Engineers Australia response to the Review of Environmental Factors for Newcastle Light Rail

**NSW Government
Transport for NSW**

May 2016

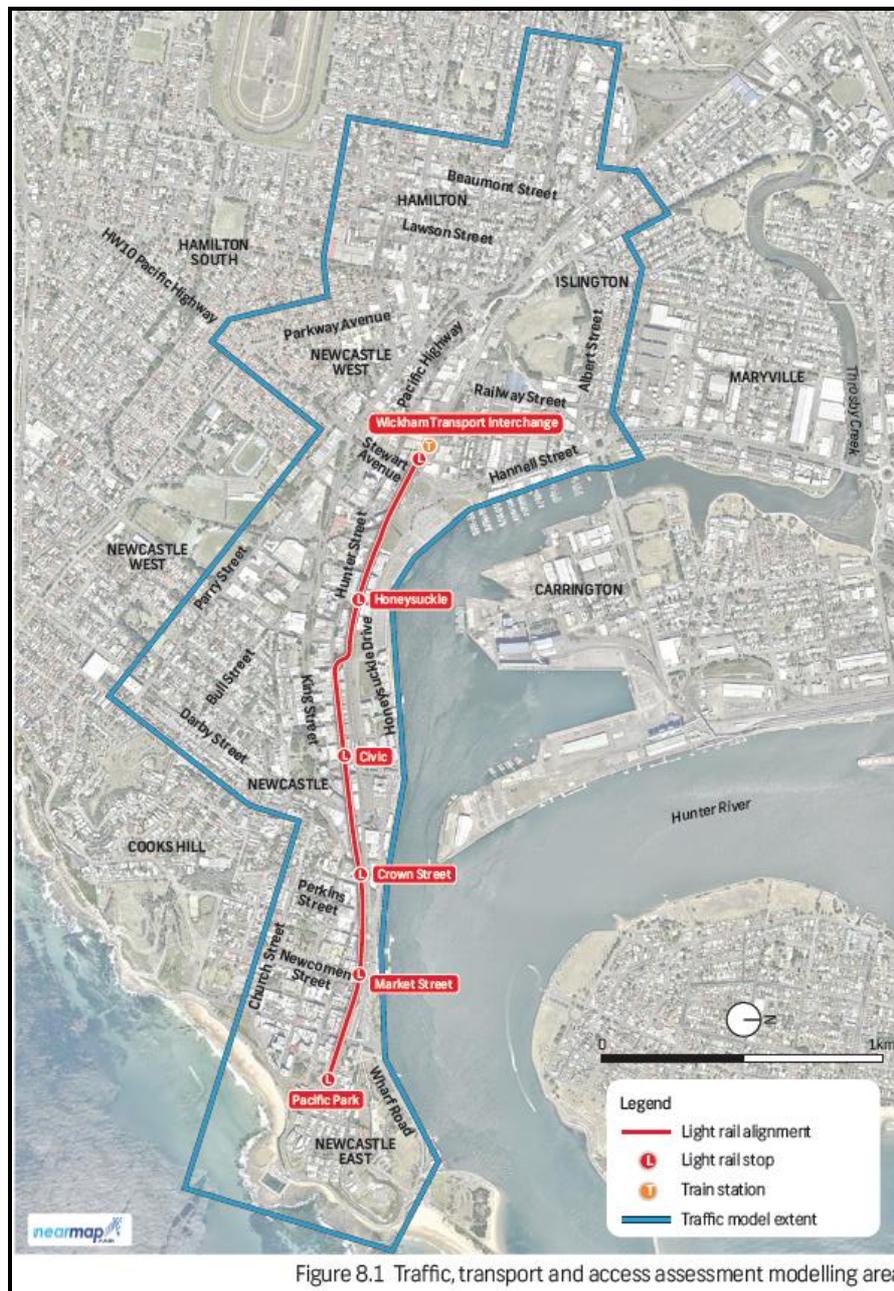
It is understood that detailed surveys were carried out on each of the major roads feeding into and out of this cordon and it is assumed that this data was used to establish external to external and external to internal trip patterns.

The REF acknowledges that the model was used to re-assign trips within this cordon. For example trips were transferred from Hunter Street to King Street and Honeysuckle Drive. However, there is no mention of any reassignment of trips outside the cordon. It is considered that the proposed restrictions to traffic flow in Hunter Street to make way for the Light Rail service will result in significant changes to

the travel patterns to and from the CBD beyond the cordon area being modeled. These changes are likely to see increased traffic flows on alternative routes serving the CBD including Union Street, Darby Street, Watt Street and Scenic Drive. Failure to consider these broader network issues significantly compromises the analysis carried out.

The only substantial output model data reported in the REF is the predicted link volumes on 30 road sections within the study cordon. There will be changes, possibly highly significant on the road network across the whole urban area.

The only consideration of north-south matters is through some SIDRA modelling. It is incomplete, and it shows failures at key junctions with north south routes – Stewart Avenue and Union Street definitely with LoS 'F' in 2028. Even the two dimensional aspects (i.e. transfer of traffic from Hunter to King and to Honeysuckle/Wharf) are incomplete in their analysis and presentation. Traffic data on Honeysuckle East and Wharf Road are missing completely.
